**CITY PLAN COMMISSION**

**FILE NUMBER:** S234-143

**LOCATION:** Grassmere Lane at Lomo Alto Drive, northwest corner

**REQUEST:** An application to replat a 0.975-acre tract of land containing all of Lot D and part of Lot F in City Block 11/5688 to create one lot on property located on Grassmere Lane at Lomo Alto Drive, northwest corner.

**EXISTING AREA ANALYSIS MAP**

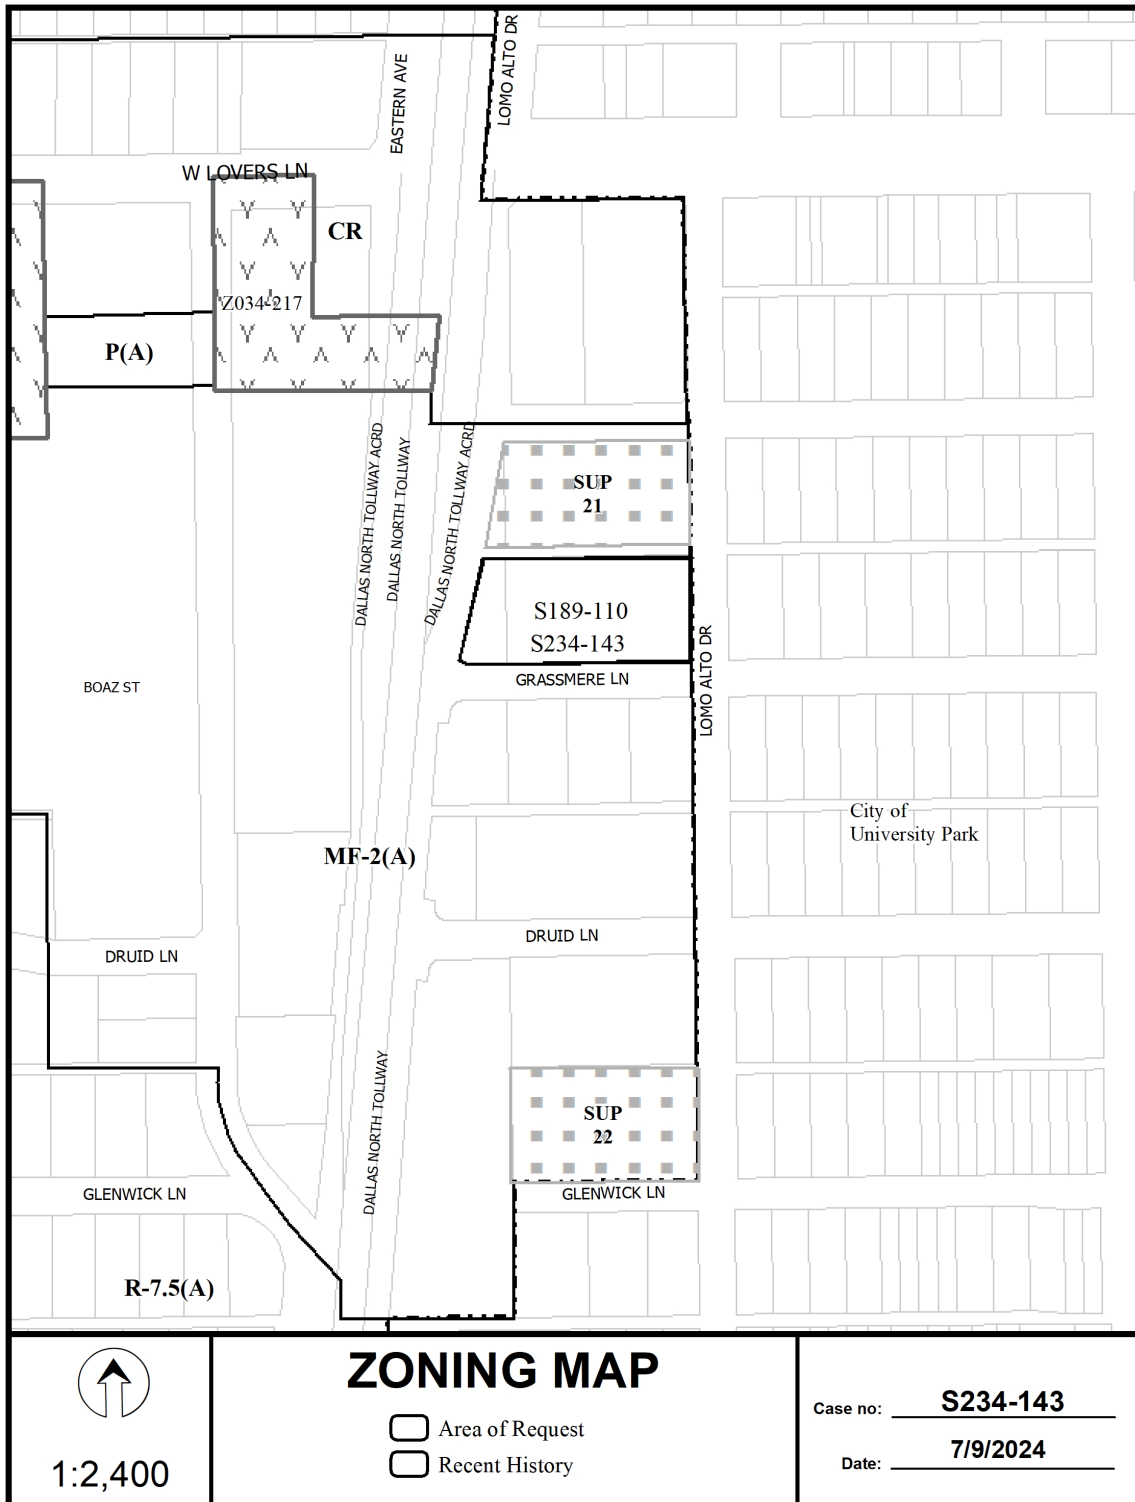
Staff finds that there is no established lot pattern within the immediate vicinity of the area (*refer existing area analysis map*); and the request is in compliance with Section 51A-8.503 and also with the requirements of the MF-2(A) Multi Family District; therefore, staff recommends approval subject to compliance with the following conditions.
